# Technical Service Bulletin

SUBJECT:			No: <b>TSB-19-42A-002REV</b>
<b>POWER WINDOW AUTO OPEN/CLOSE FUNCTION INOPERATIVE - REVISED</b>			DATE: <b>October 2019</b>
			MODEL: <b>2019-2020 Eclipse Cross, Outlander, Outlander PHEV</b>
<b>CIRCULATE TO:</b>	<input type="checkbox"/> GENERAL MANAGER	<input checked="" type="checkbox"/> PARTS MANAGER	<input checked="" type="checkbox"/> TECHNICIAN
<input checked="" type="checkbox"/> SERVICE ADVISOR	<input checked="" type="checkbox"/> SERVICE MANAGER	<input checked="" type="checkbox"/> WARRANTY PROCESSOR	<input type="checkbox"/> SALES MANAGER

*This bulletin supersedes TSB-19-42A-002, issued April, 2019, to add 2020 model year, and more cases where the power window switch may become inoperative. Revisions are italicized and indicated by ◀.*

### Driver's Door Power Window Switches

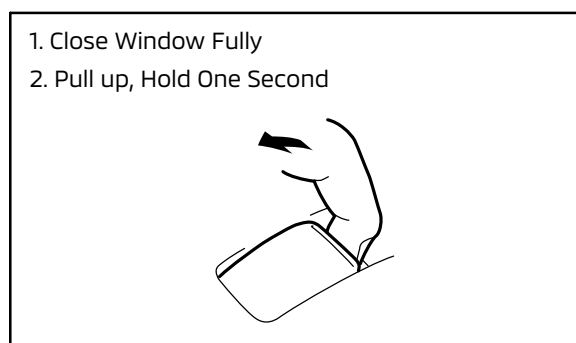
Starting with 2019 model year in affected vehicles listed below, the power window system calculates the window position from the current flows to the motor. This creates a gap between actual and calculated window position when the motor moves by inertia even after the motor current stops. This gap becomes greater after the power window switch is *operated in any of the ways described above*. As a result, the auto open/close function becomes inoperative and the normal entrapment prevention while the window is closing may not work properly.

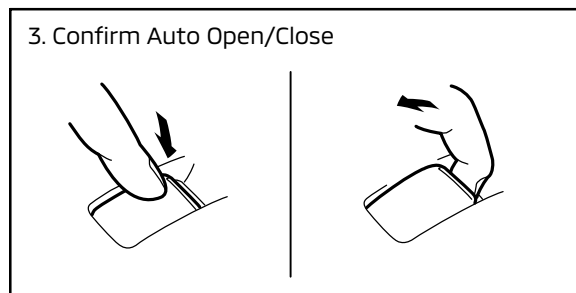
If the power window auto open/close function becomes inoperative, follow the steps below.

1. Close the window fully by operating the switch manually until the window is closed completely.
2. Once window is in closed position, pull up on the switch again and **hold for one second**, then release.

3. Confirm the the auto open/close function is working as expected on all windows (if applicable).

4. If the auto open/close function does not recover, perform troubleshooting as necessary referring to the applicable Service Manual.
5. Explain to the customer that this is a safety function and not a failure.
